Subject: OST Services' (OSTS) Report No. 1440  
OST Services' (OSTS) Job No. 005-12  
Hot and Cold Inspections of Piping and Supports  
Unit No. 2 – Spring of 2012

INSPECTION OF  
HIGH ENERGY PIPING AND SUPPORTS

MITCHELL STATION - UNIT NO. 2

DENNIS A. SCHMEDINGHOFF  
OSTS' REPORT NO. 1440  
OSTS' JOB NO. 005-12

**Figure No. 6**  
**2-MS-H9 Tilted Down on South Side**

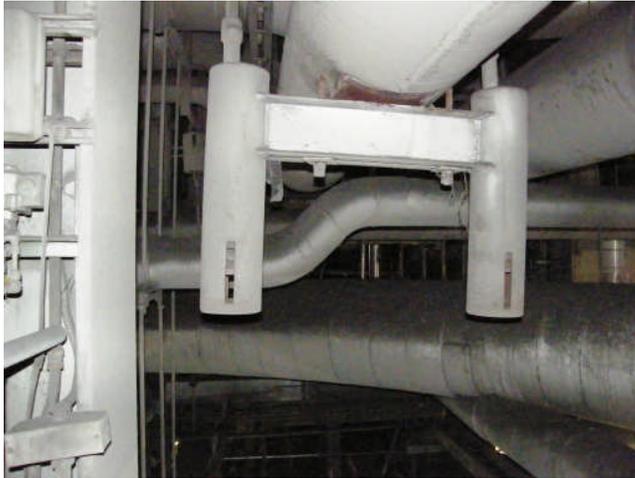
This variable spring trapeze assembly has a loose U-bolt. The southernmost support rod is slightly distorted, and the support is slightly tilted downward to the south. The U-bolt anchors the piping to the support. We recommend that the plant budget for scaffolding and allow manpower to tighten the U-bolt and adjust the support as necessary (Figure No. 6).

**Figure No. 7**  
**2-FRSH-4 Bottomed Out**

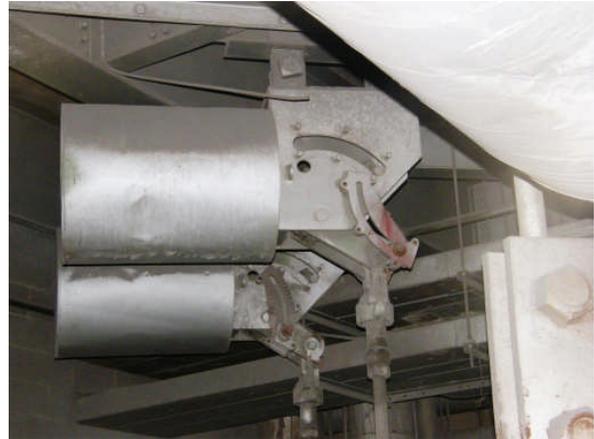
These two mark numbers represent constant support hangers. They are bottomed out in the hot condition (Figure No. 7). We recommend that the

supports be load tested prior to making any adjustments. There is also the possibility that the piping is distorted along the lower horizontal run and this should be explored. If distortion is present, then adjustments at this time could exacerbate the condition.

**Figure No. 8**  
**2-FRSH-5 Notation**

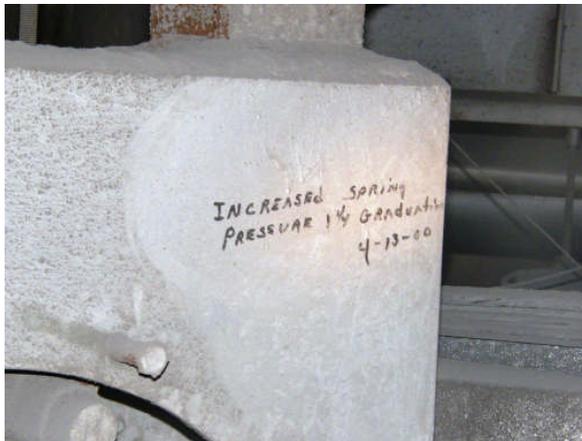
Another possibility is that the supports were adjusted improperly. During the outage of 2010 scaffolding was built to allow access to support 2-FRSH-5 to verify design information contained on the name plate. The name plate could not be found as they appear to have been removed. There was a notation written on one of the spring cans that stated the spring tension had been increased in April 2000 (Figure No. 8). There is an adjustment that allows for at least 10% adjustability. More likely, the travel was adjusted by a well intentioned, uninformed individual who thought they were adjusting the spring tension.

It appears likely, that the condition of being bottomed out in the hot condition is due to an adjustment to the travel in the cold condition in 2000.

**Figure No. 9**  
**2-FRSH-7 Topped Out Cold**

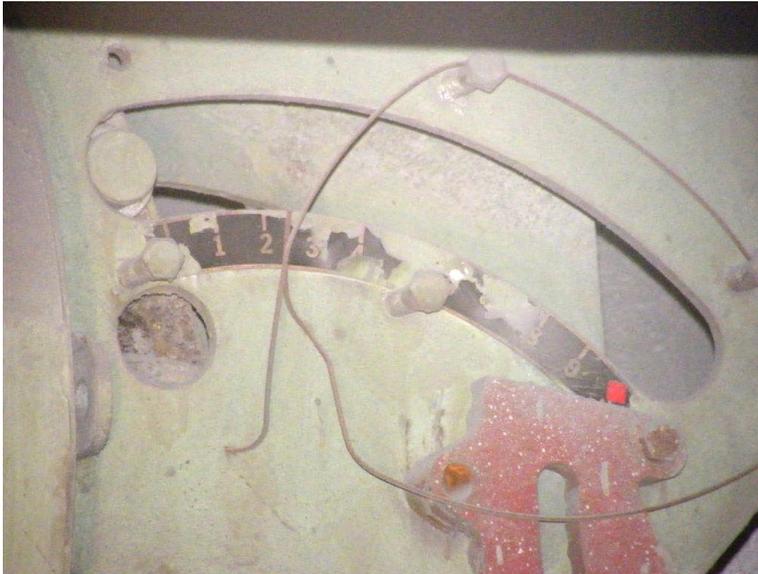
This constant support designed settings were to be bottomed out hot and 6.5 cold. The support is topped out in the cold condition (Figure No. 9). This could be due to distortion of the piping if it is "humped" at this location, or someone performed adjustments without consulting the original hanger design sketches.

**Figure No. 21**  
2-FWH-31 added modification

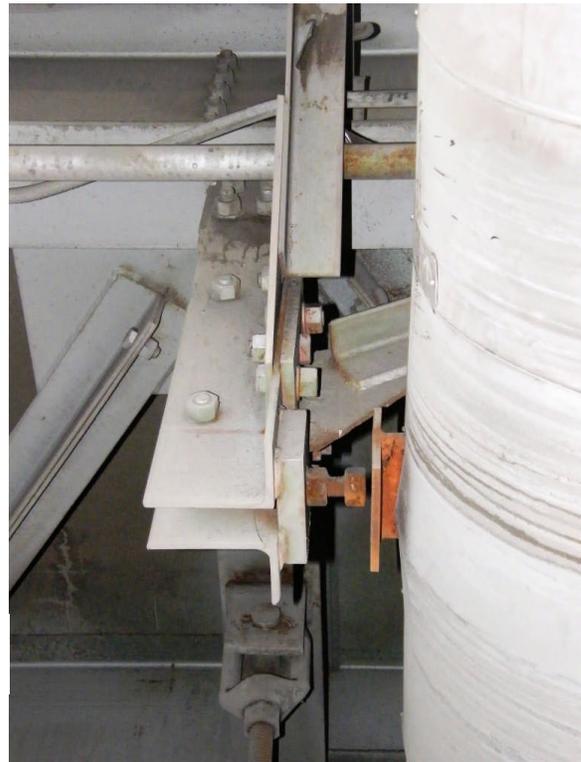
This support is part of the modifications made to the piping system. It is a limit stop installed to limit lateral movement to the west (Figure No. 21). The hanger designation was added for purposes of this report, and is not on file at the plant.
